DESCRIPTIVE REPORT

Type of Survey ... Basic Hydrographic
Field No. HFP-10-4-84
Registry No. H-10157

State Maine
General Locality .. Penobscot River
Sublocality Leaches Point & Verona
..... Park to Treat Hill
..... 19 84-85

Descriptive Report
To Accompany Hydrographic Survey
H-10157

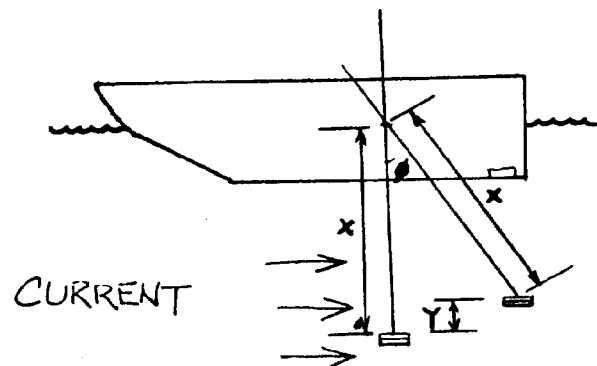
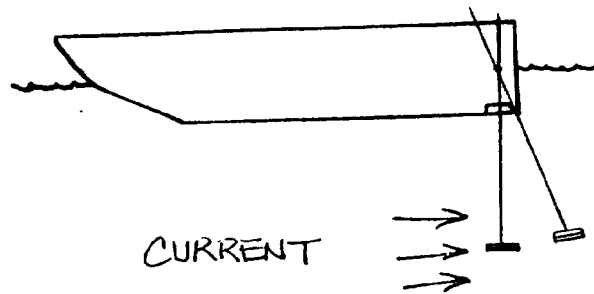
See Section D of the descriptive report for an explanation of the problem taking bar checks. A sketch is attached to ensure proper visualization.

Due to the especially strong currents in the survey area, accurate bar checks could not be made every day. Also, some of the checks at greater depths, 20-40 feet, were ignored due to excessive uplift of the bar by the current, a pendulum effect, causing an exaggerated correction. Bar checks were attempted near "slack" water to try to compensate for the current's effects on the bar.
